# Groundwater Application Review Summary Form

Application # LL- 1837

GW Reviewer Phillip I. Marcy Date Review Completed: 07/30/2020

**A. GENERAL INFORMATION:** Applicant's Name: Knife River Corporation County: Linn

Well Location Map

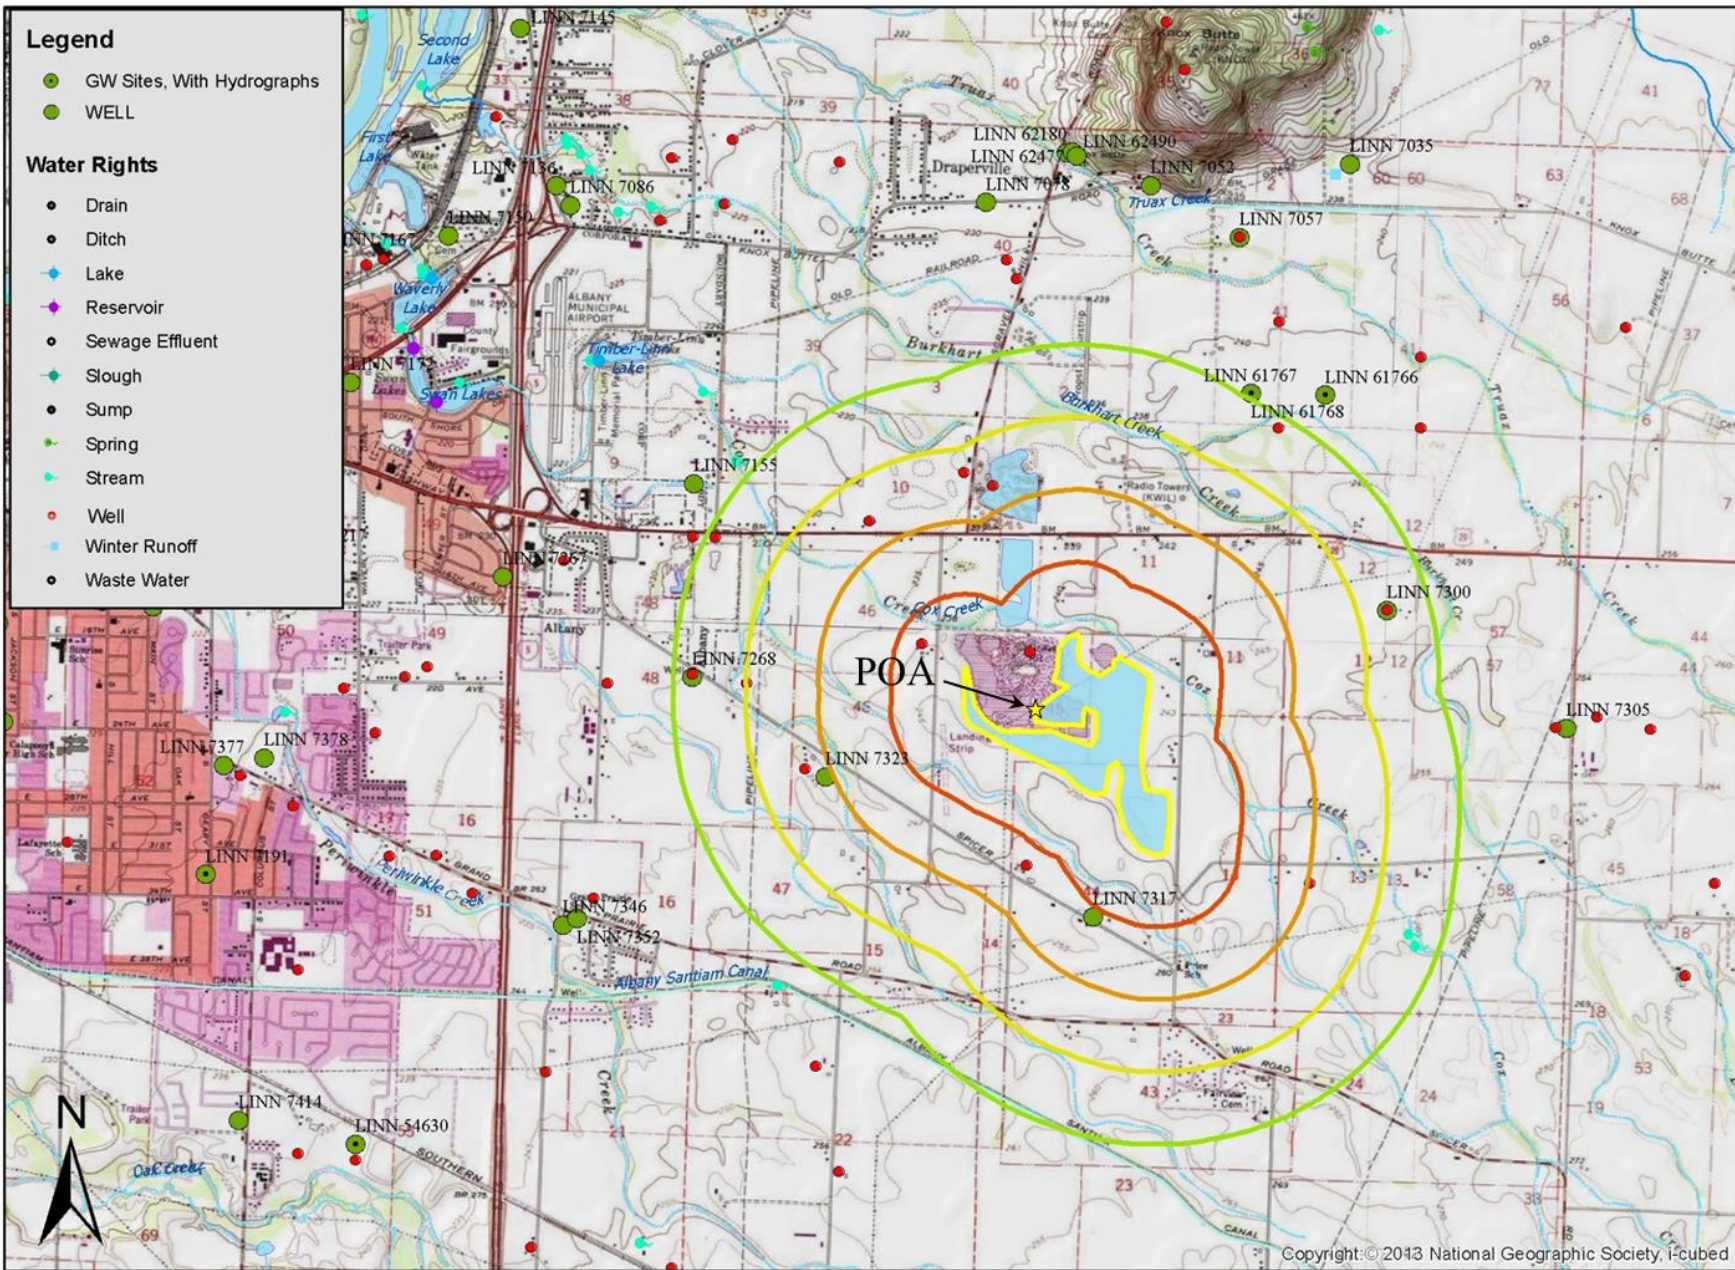
A1. Applicant(s) seek(s) 3.06 cfs from 1 well(s) pond in the Willamette Basin,  
 \_\_\_\_\_ subbasin

Well	Logid	Applicant's Well #	Proposed Aquifer*	Proposed Rate(cfs)	Location (T/R-S QQ-Q)	Location, metes and bounds, e.g. 2250' N, 1200' E fr NW cor S 36
1	POND	1	Alluvium	3.06	11S/3W-11 SW-SW	550'N, 1010'E fr SW cor S 11
2						
3						
4

A5.  **Provisions of the** Willamette (OAR 690-502-0240) Basin rules relative to the development, classification and/or management of groundwater hydraulically connected to surface water  **are, or**  **are not,** activated by this application. (Not all basin rules contain such provisions.)  
 Comments: The proposed groundwater source is not within 1/4 mi of surface water features so provisions of OAR 690-502 do not apply.

**Basis for aquifer hydraulic connection evaluation:** There are no perennial surface water sources within one mile of the pond proposed as the groundwater POA;
